LONGHORN ARMY AMMUNITION PLANT

ADMINISTRATIVE RECORD

VOLUME 9 of 10

***LONGHORN ARMY AMMUNITION PLANT
KARNACK, TEXAS
ADMINISTRATIVE RECORD - CHRONOLOGICAL INDEX***

FIGURE 2.

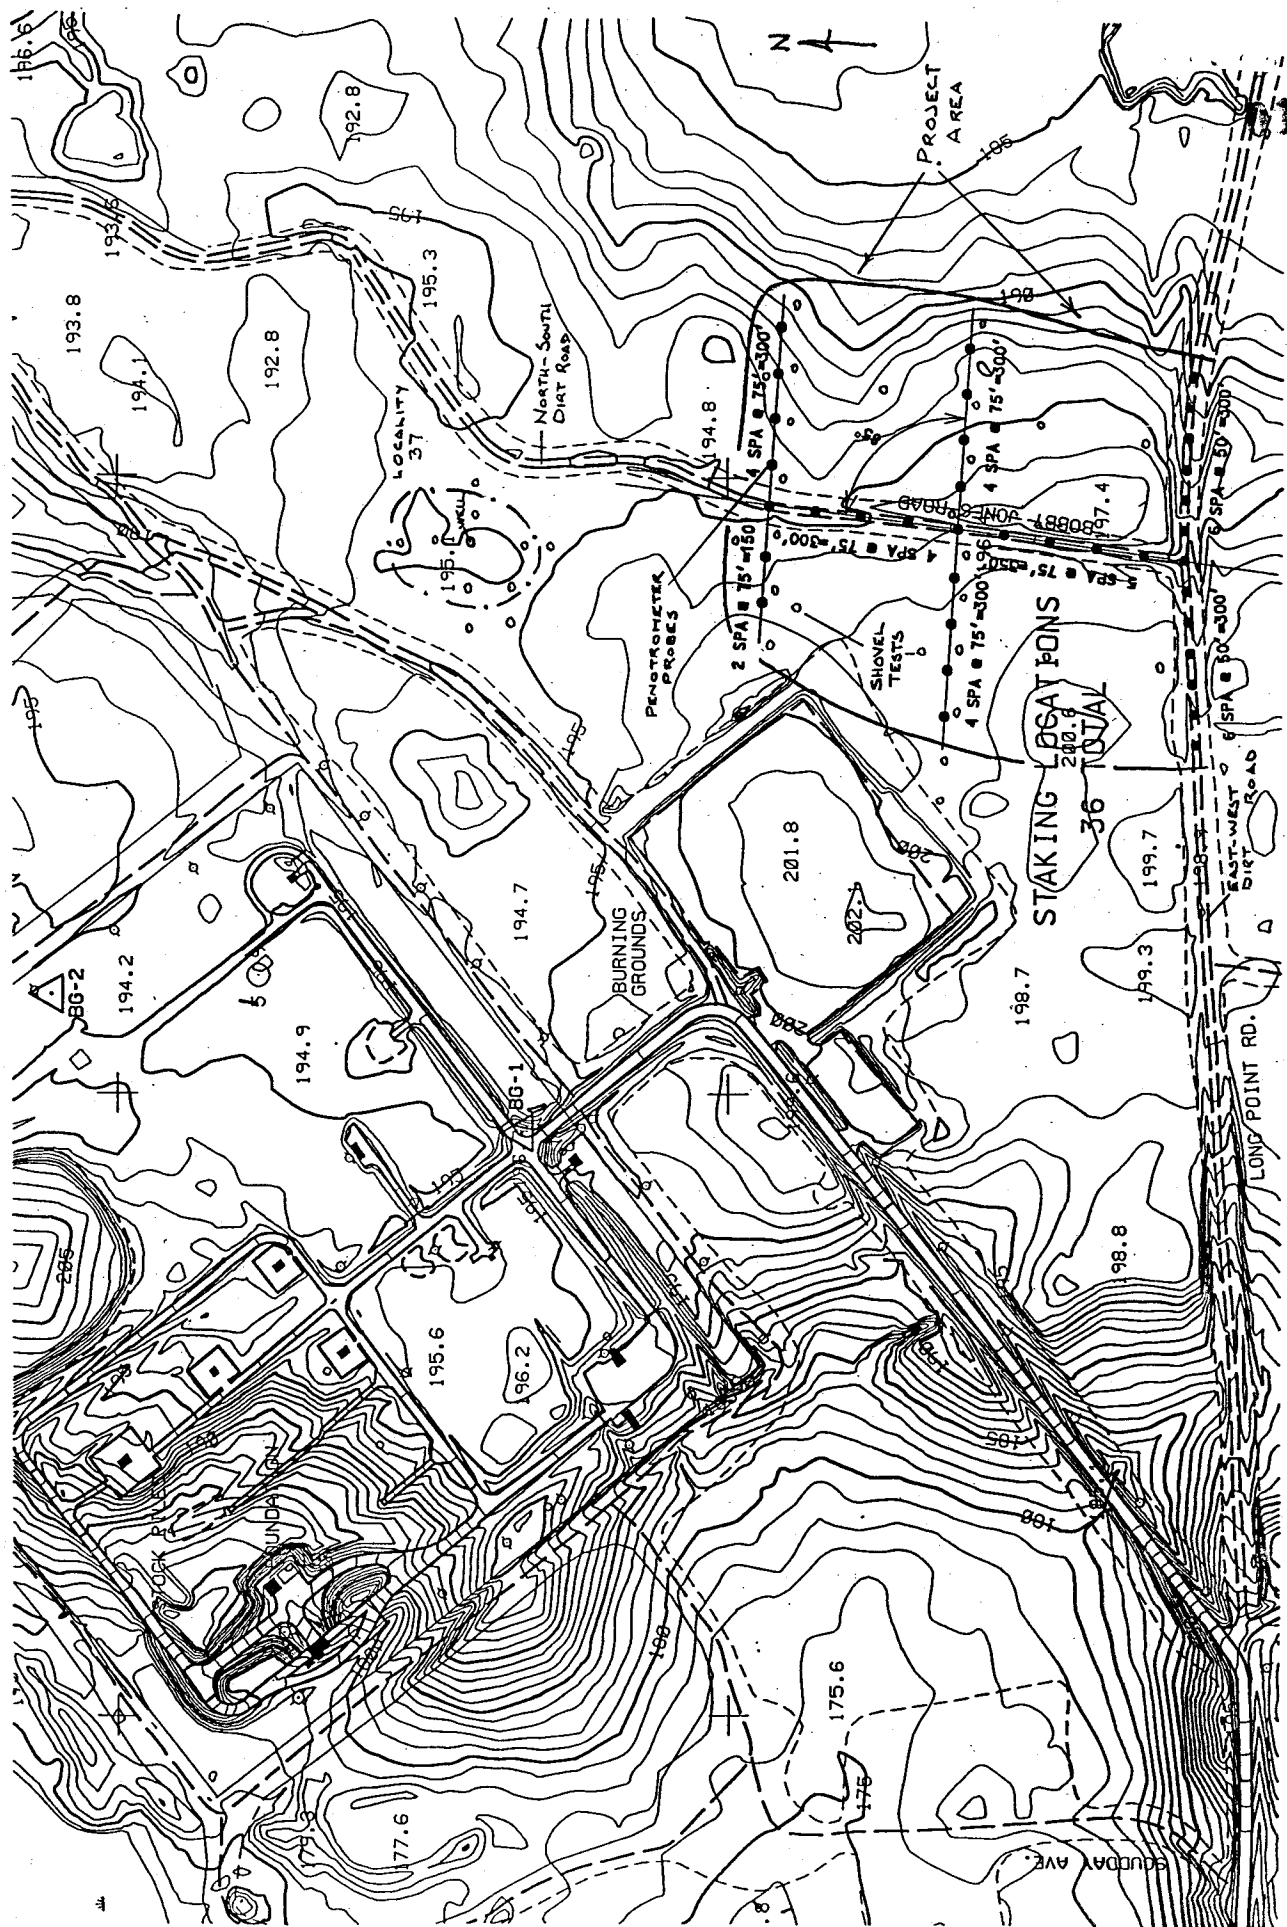
homestead site (Locality 37), consisting of a brick line well, bulldozed brick pile, and associated ornamental plants, were discovered near, but off-site from Dump Site No. 63 (see Figure 2) (Peter and Hanson 1990:37).

Locality 37 was also inspected in order to define the site limits. The site limits at this historic site were defined by observable features, such as the brick-lined well and brick pile, a few artifacts, and a cluster of oak trees. Ten shovel tests were also excavated at this site (see Figure 2).
